**AIP SUPPLEMENT
(SUP)****H149/25****Effective: 202508280500 UTC**

**MELBOURNE AIRPORT (YMML)
COMMISSIONING OF TWY D AND
ASSOCIATED WORKS****1. INTRODUCTION**

1. TWY D Commissioned - Stage 7 (completed)

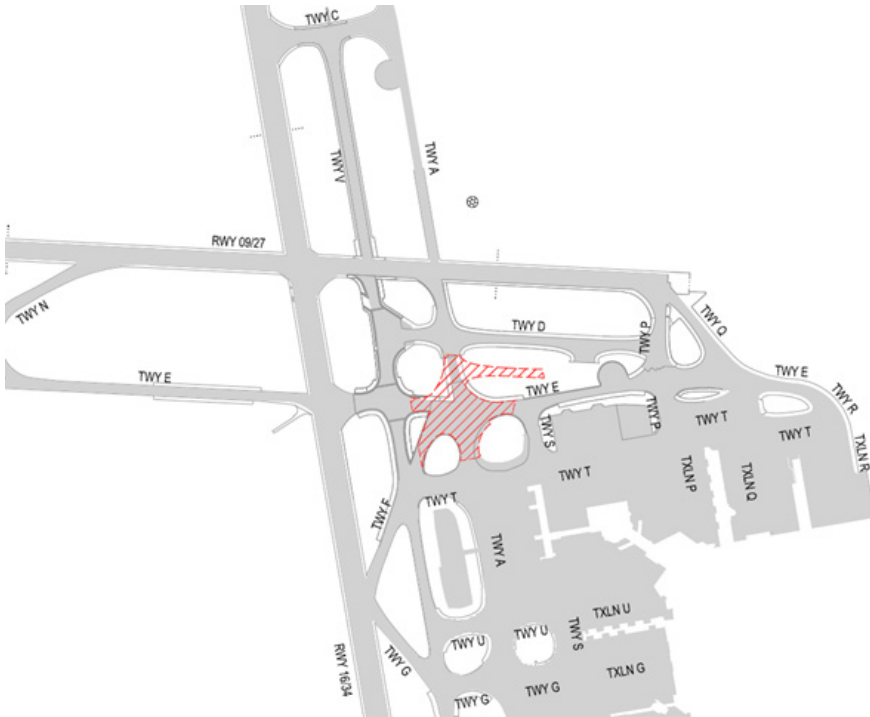
TWY D was commissioned parallel to RWY 09/27 between TWY P and V on 08 APR 2025. Refer Appendix 1.
 - 2.1.2 Stage 8

2. TWY A and E Intersection Closure - Stage 8

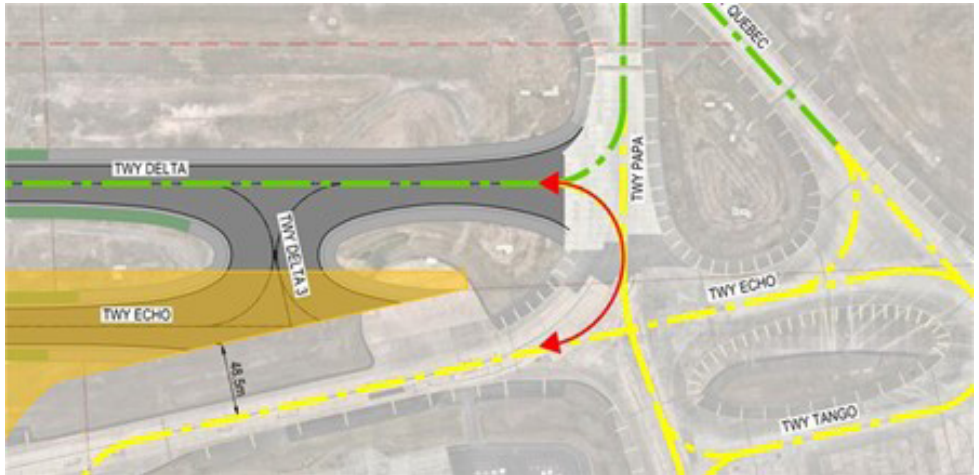
Intersection closure of TWY A and E allowing for early works in preparation for TWY E realignment on 09 APR 2025. Refer Appendix 2.

AERODROME GROUND MOVEMENT CHART - Page 1 MELBOURNE, VIC (YMML)

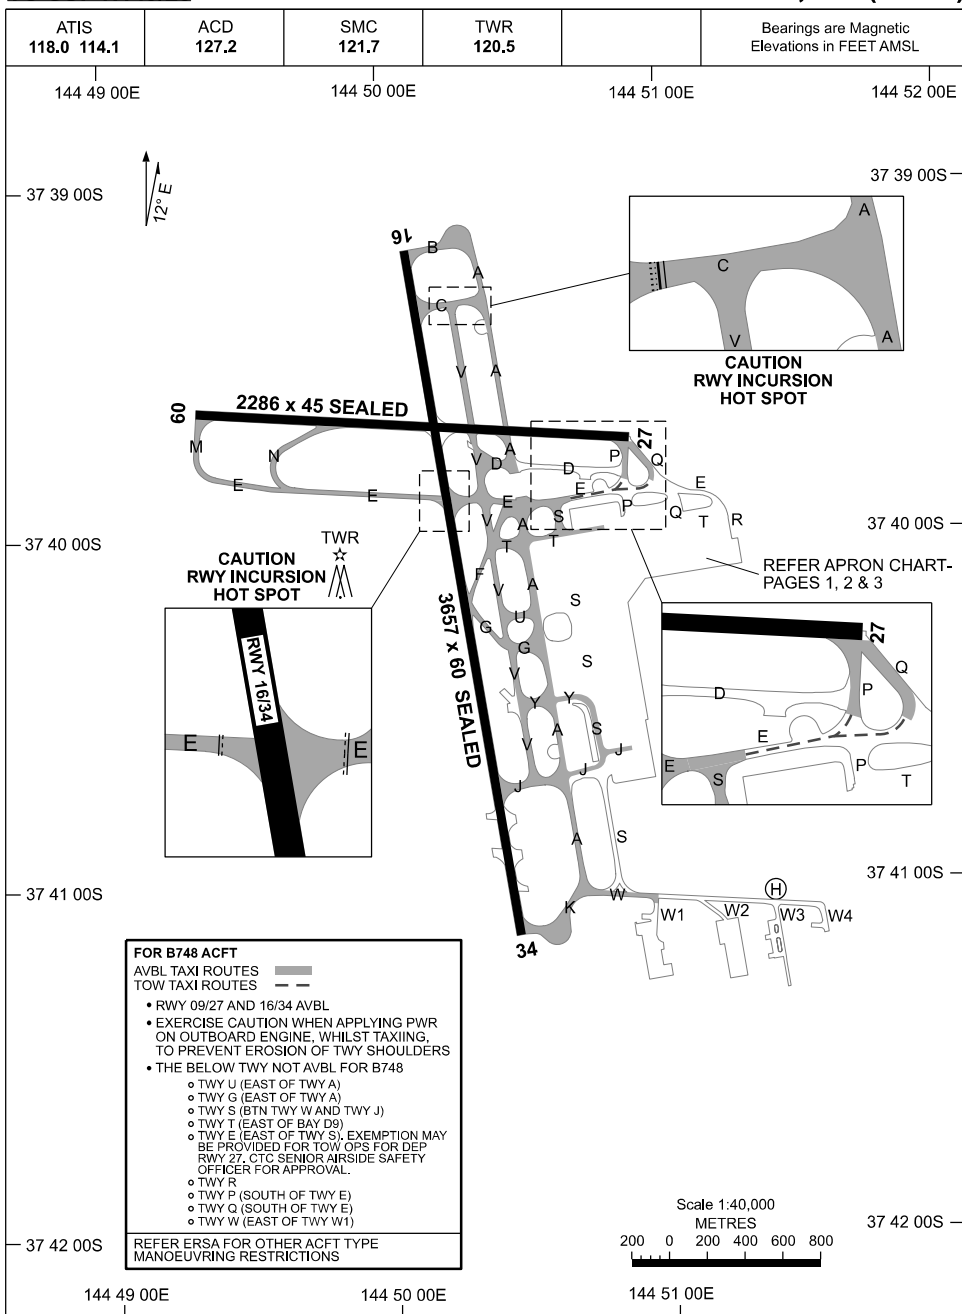
- 3.1 The full length of TWY D accommodates Code E ACFT with a MAX wingspan of up to, but not including 65M, and up to, but not including 15M outer main gear wheel span.
- 3.2 Effective on publication of this SUP, TWY D between TWY A and V has been upgraded to a Code F TWY. TWY D between TWY A and P will be upgraded to a Code F TWY at the completion of all stages of work.
- 3.3 The full length of TWY D is available for use in RVR conditions of less than 350M (CATII/CATIII). Refer Appendix 3.
- 3.4 Approved Taxi Routes
 - 3.4.1 Taxi Routes published in DAP – TWY D between TWY A and P not available for B748 and A380, refer Appendix 5 and 6.

Changes: TAXI ROUTES.

AERODROME GROUND MOVEMENT CHART - Page 2 **MELBOURNE, VIC (YMML)**

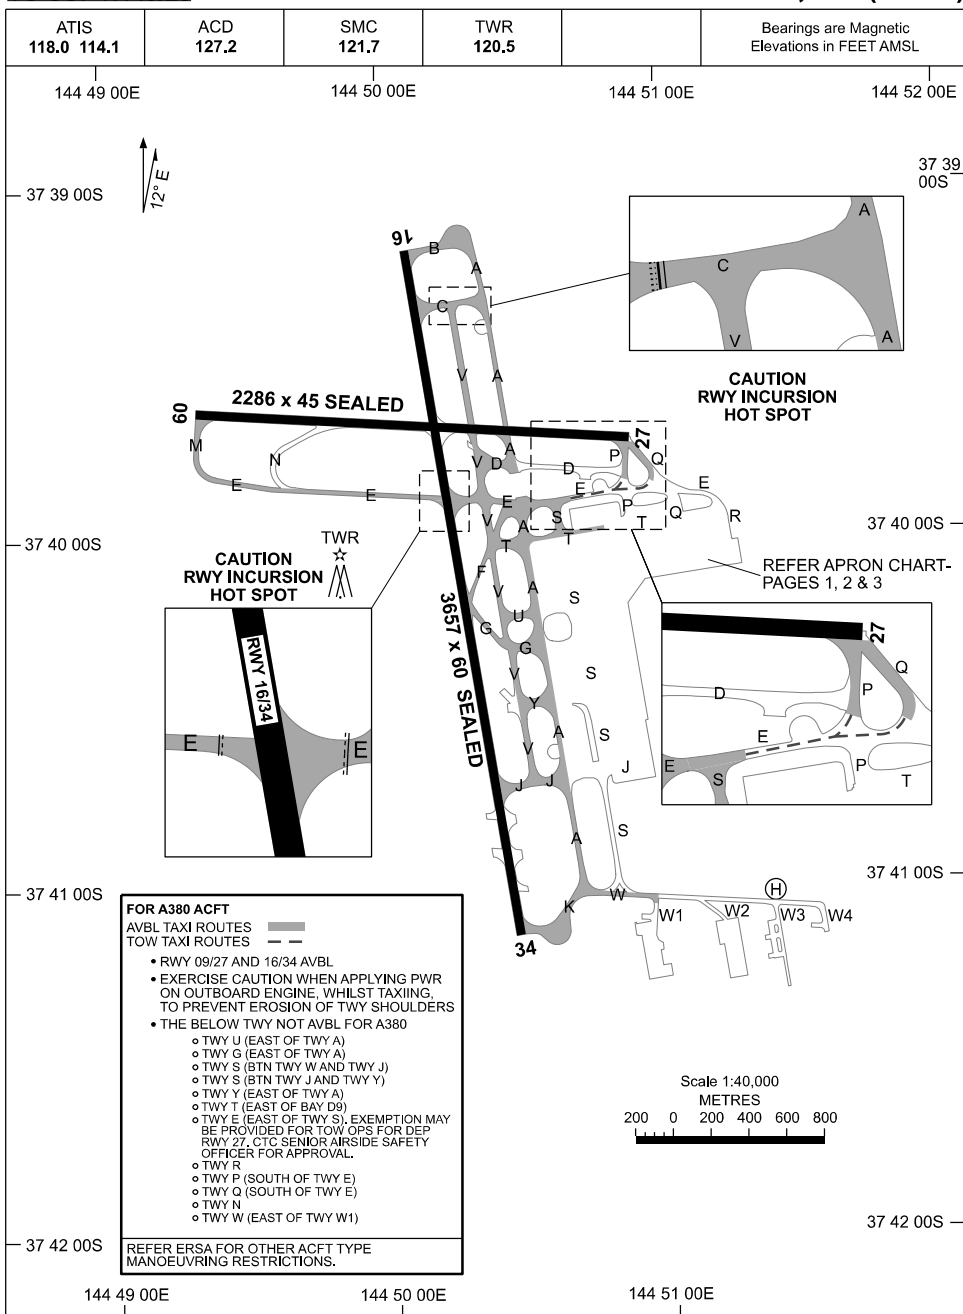
Changes: TAXI ROUTES.
